**DIAMOND HILL
COMMUNITY DEVELOPMENT DISTRICT**

POND INSPECTION REPORT

Technical Memorandum

Project Name: SWFWMD ERP Permit Report

40

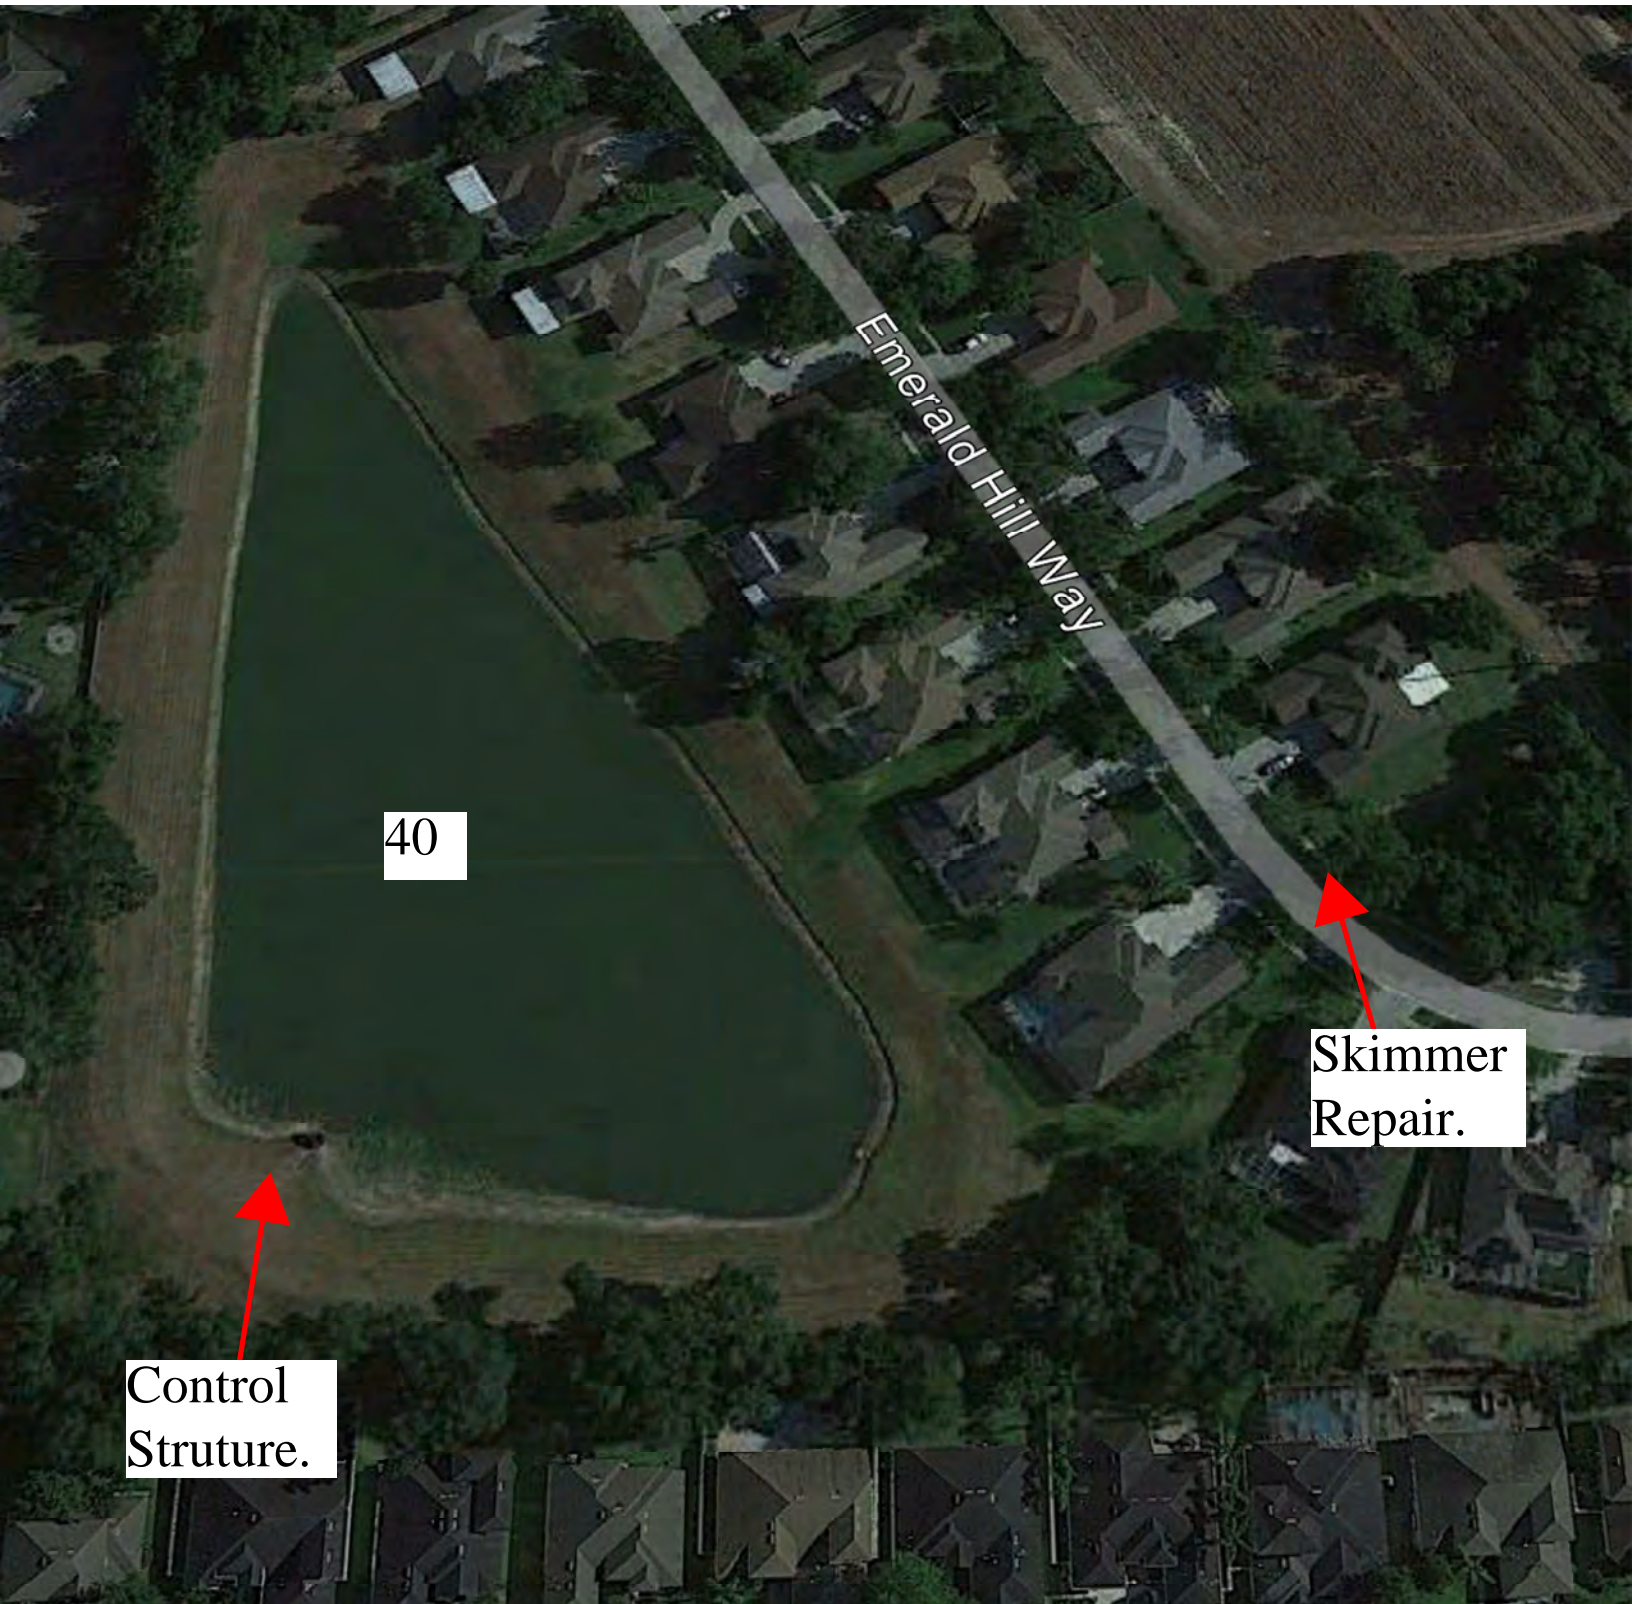
CONDITION OF POND STRUCTURES (CONTROL STRUCTURES, MITERED END SECTIONS, INLETS)			
Severity Ranking:	Minor		
Type of Damage:	Control Structure		
Structures Notes: One control structure with skimmer observed. One of the grates is rusted and warped topping the control structure. Some cracks in concrete structure. Behind structure is eroding away and will soon expose pipe. Two FES's observed in operational condition with no defects. There is a control structure (525 in plans) that is adjacent to pond 40 and has a broken skimmer in need of repair.

Control
Struture.

Skimmer
Repair.

1600

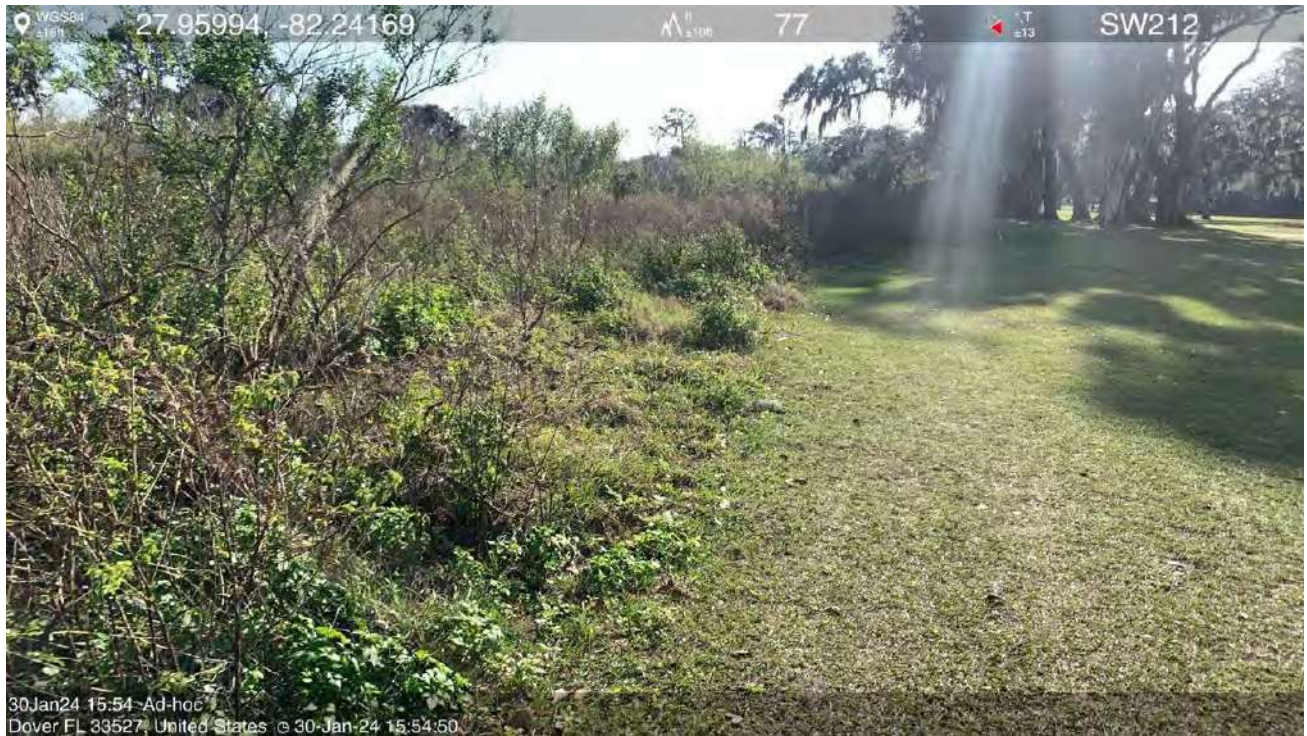
CDD POND EVALUATION			
INSPECTION DATE:	1/30/2024	PERMIT NUMBER:	24679.003
INSPECTED BY:	Jerry Whited	POND PERIMETER:	2,190 ft
POND NUMBER:	1600	POND AREA:	234,643 sq ft
Full Pond Access:	No	Trash Observed:	No
Benifitial Vegetaion Present:	No	Water Quality:	NA
Tailwater Issue Observed:	No	Water Quality Notes:	NA
Observed Depth:	0	Observed Temperature:	NA
POND ELEVATION ANALYSIS			
Treatment Type:	Dry Filter	Design Bottom Elevation:	60
Weir/Orifice Elevation:	71.5	Observed Bottom Elevation:	60
Skimmer Bottom Elevation:	71	Elevation Difference:	0
Pond Elevation Notes: This is a dry pond.			
BANK EROSION AND SCOUR			
Severity Ranking:	NA		
Type of Erosion:	None		
Bank Erosion Notes: No erosion or pond bank defects observed.			
CONDITION OF POND STRUCTURES (CONTROL STRUCTURES, MITERED END SECTIONS, INLETS)			
Severity Ranking:	Access		
Type of Damage:	Grate Inlet		
Structures Notes: There is one grate inlet that is not accessible due to vegetation overgrowth. From historical records it looks like the area stopped being maintained or mowed in 2016-17. The lack of maintenance the golf course is doing is effecting our access as well. Grate inlet needs to be uncovered. Vegetation must be cleared to provide access. Access needs to be maintained regularly. Recommend full pond quarterly maintenance.

Inlet grate is buried in vegetation, need access.

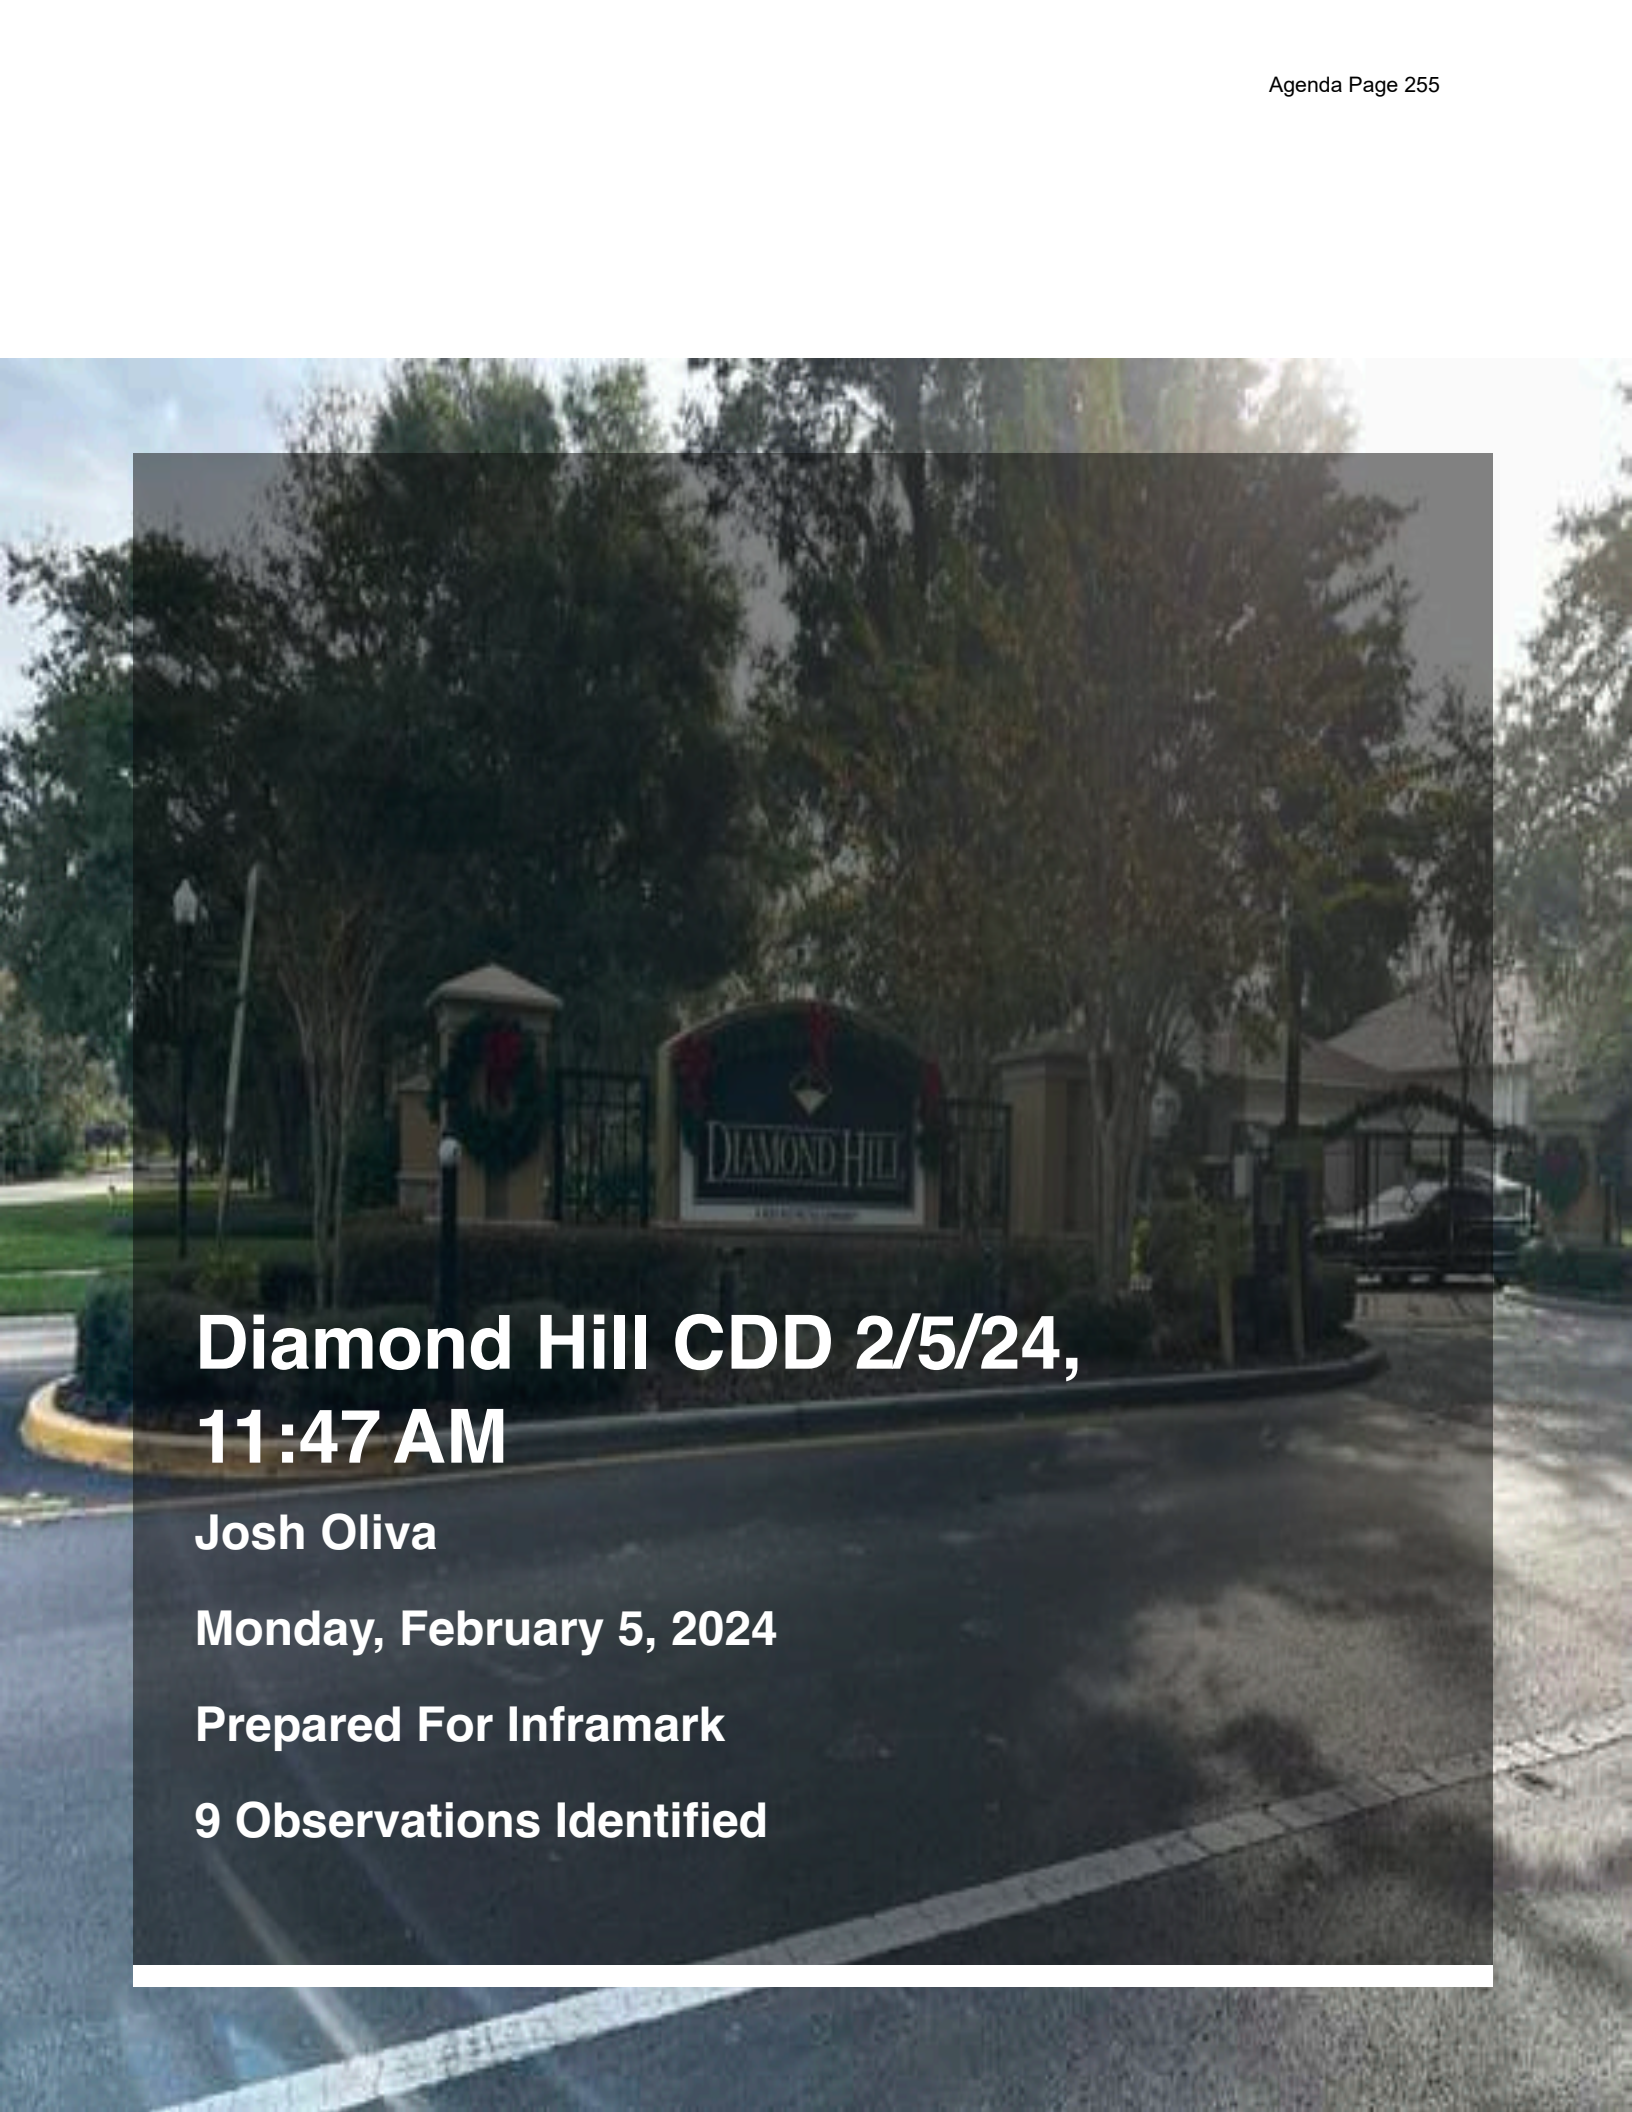
Comments: Dislodged grate from CS 40 within Pond 40

Comments: View of missing grate from CS 40
